**ANSI/ASHRAE Addenda l, m, n, o, and s to  
ANSI/ASHRAE Standard 62.1-2007**

## **Ventilation for Acceptable Indoor Air Quality**

### Addendum I to 62.1-2007

Delete the existing Figure D-1 and insert new Figures D-1 and D-2 as shown.

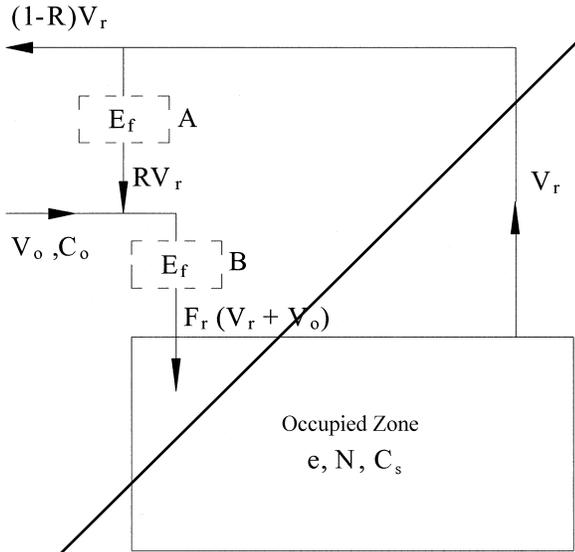
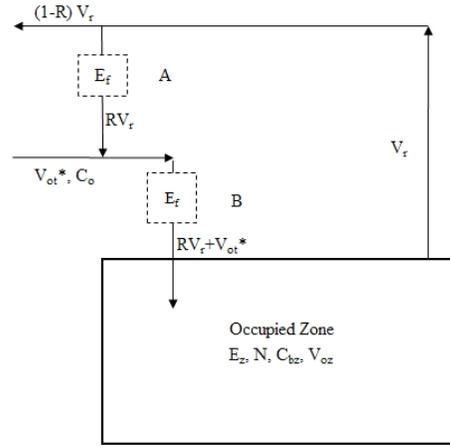
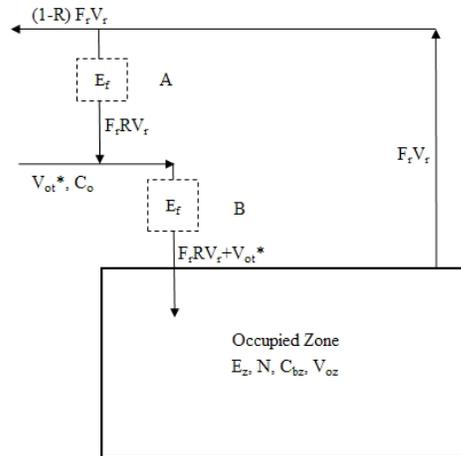
- *Improve variable-name consistency with body of the standard and Appendix A.*
- *Delete one figure, replace with two improved figures.*
- *Delete “proportional” systems from Table D-1, since VAV systems with fixed-position outdoor air dampers are unlikely to meet the requirements of the standard and should be discouraged.*

Figures D-1 and D-2 show ~~D-1 shows~~ representative single-zone systems. A filter may be located in the recirculated airstream (location A) or in the supply (mixed) airstream (location B).

**Figure D-1 Ventilation system schematic—constant volume system with no infiltration/exfiltration. (\* $V_{ot} \equiv V_{oz}$  for single-zone systems.)**

**Figure D-2 Ventilation system schematic—variable air volume system with no infiltration/exfiltration. (\* $V_{ot} \equiv V_{oz}$  for single-zone systems.)**
